Simplified AM Sync Up

IEEE

May 2013 Victoria

Introduction

Figure 91-4—Alignment marker mapping to FEC lanes

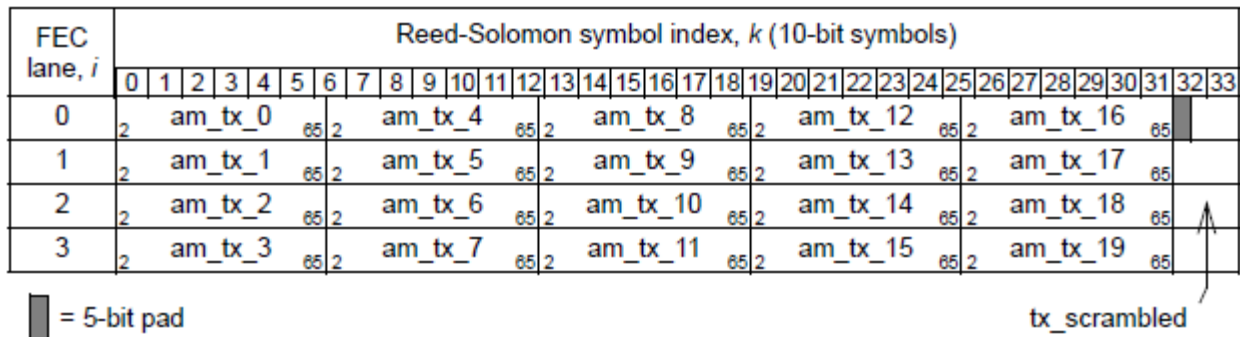
- The draft also allows any logical lane to appear on any physical lane
- To sync up to the AMs quickly, a parallel search much take place on each lane, looking for any of the 4 lead AMs (0-3). EEE complicates this more.
- This is a significant amount of logic, which can dominate the non FEC portions of the FEC sublayer
- Is there a simpler way which will reduce the logic?
- This was not a problem for 802.3ba since there we obtain block lock before looking for AMs

- Repeat AM0, and AM16 across all 4 lanes
- That allows the receiver to do a parallel search for a single pattern instead of 4 different patterns across all lanes, then the logical lane number is identified by the other AMs
- In order to maintain BIP transparency, the BIP fields are not replaced, instead just M0-M3 and M4-M6
- AM0 is repeated for normal lock, and AM16 is repeated for EEE mode where you lock to both the first and fifth AM

- Change the mapping for the exceptions that would be for the first and last AMs per lane (repeating AM0 and AM16). Includes and update to figure 91-4

0	AM0	AM4	AM8	AM12	AM16
1	AM0	AM5	AM9	AM13	AM16
2	AM0	AM6	AM10	AM14	AM16
3	AM0	AM7	AM11	AM15	AM16
